**Subject: Docket Nos. 50-361 and 50-362
Proposed Change Number (PCN)-548, Revision 1
Battery and DC Sources Upgrades and Cross-Tie
San Onofre Nuclear Generating Station, Units 2 and 3**

SUBJECT: Proposed Change No. 548, Rev. 1, is a request to revise Technical Specifications (TSs) 3.8.1, "AC Sources – Operating," 3.8.4, "DC Sources – Operating," 3.8.5, "DC Sources – Shutdown," 3.8.6, "Battery Cell Parameters," 3.8.7, "Inverters – Operating," and 3.8.9, "Distribution Systems – Operating." This change will also add a new Battery Monitoring and Maintenance Program, section 5.5.2.16. This change will extend the Completion Time for an inoperable subsystem battery by allowing manual cross-connect of distribution subsystems, upgrade to the 2002 Revision of IEEE 450, include improvements included in Revision 1 to Technical Specification Task Force (TSTF) – 360, and make editorial modifications more consistent with industry use.

Attachment 2: DC System Configuration Diagrams (Sketch 1 and 2)

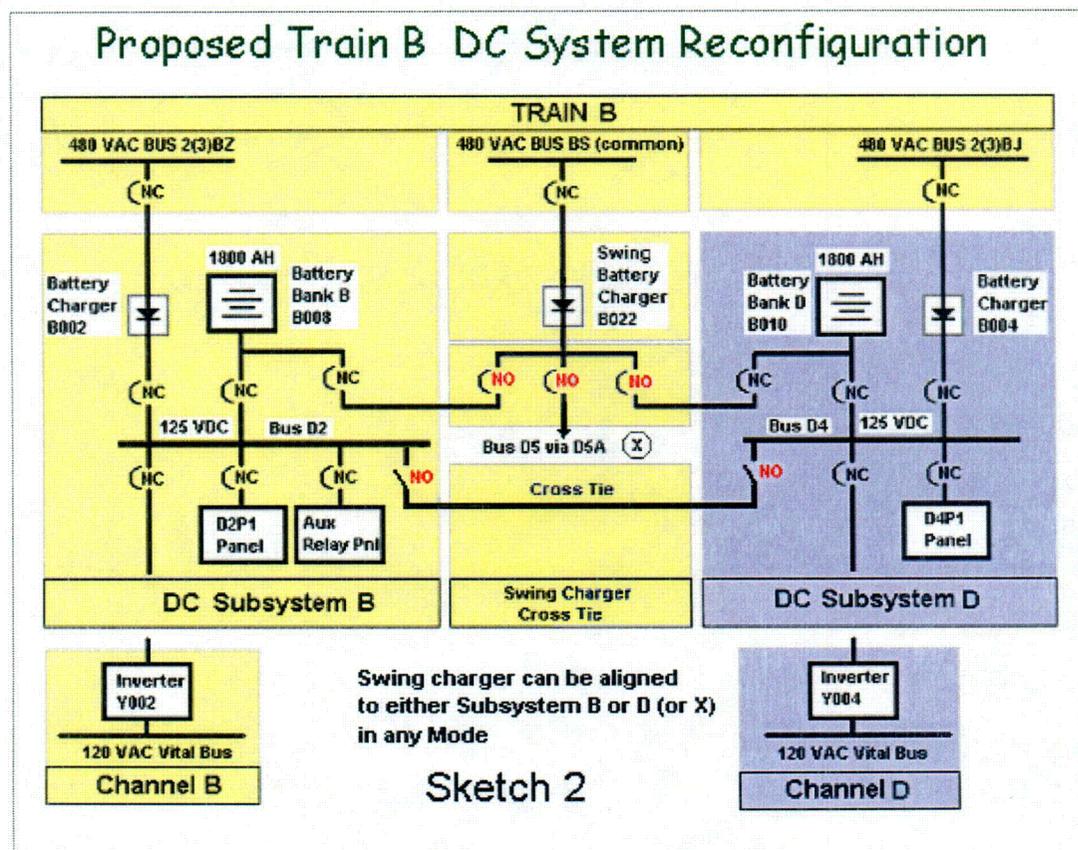
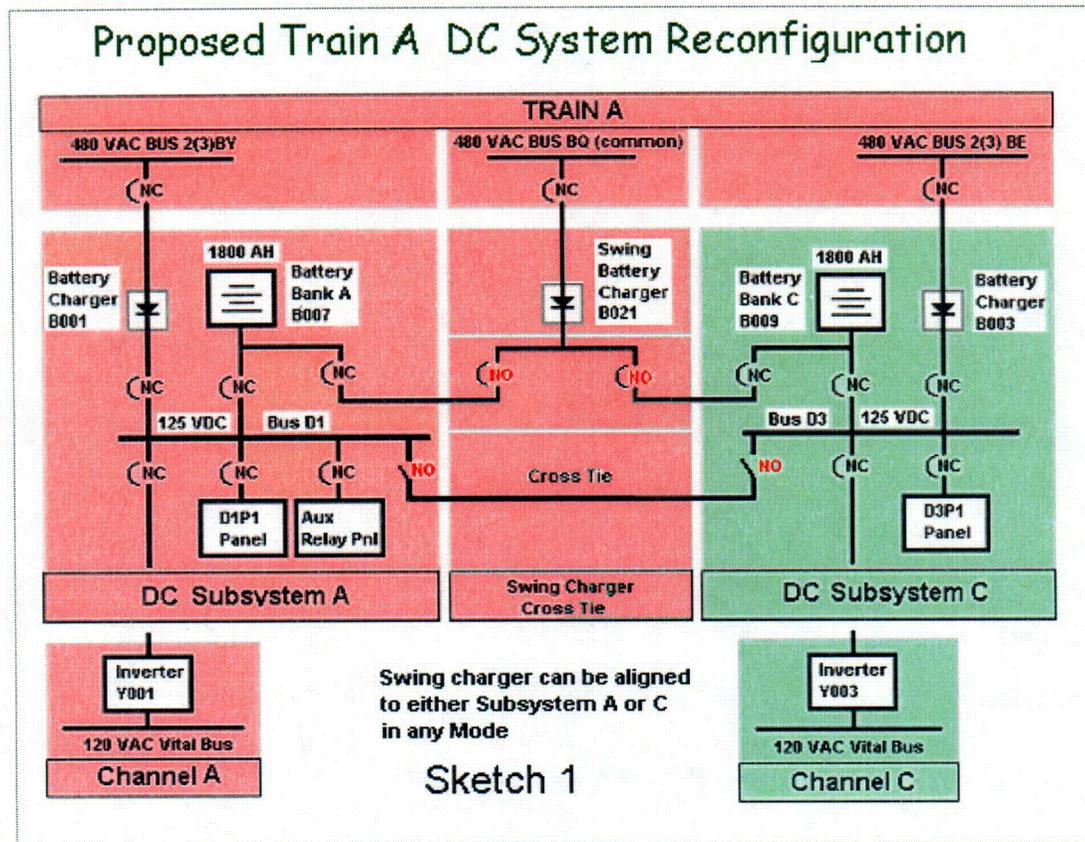
To be able to fully utilize the flexibility provided by the proposed TS, design changes are currently being made to the electrical system to provide the ability to manually cross-connect DC subsystems during operating Modes 1-4 and continue to meet General Design Criteria (GDC) 17, GDC 18, Regulatory Guide (RG) 1.6, and IEEE 308. These design changes include one new swing battery charger to be shared by subsystems A and C and another by subsystems B, D, or non-1E bus D5. Electrical isolation and independence between subsystems required by RG 1.75 is maintained by the isolation capability of the battery charger itself and the kirk key interlocked output circuit breakers. The existing batteries for each train are being replaced with batteries with 1800 amp-hour ratings. (Refer to Sketches 1 and 2 of the post-modification system in Attachment J, Review Aid). Currently, the subsystems A and B batteries are rated 1260 amp-hours nominal 8-hour, and the subsystems C and D batteries are rated 1800 (previously 1500) amp-hours nominal 8-hour.
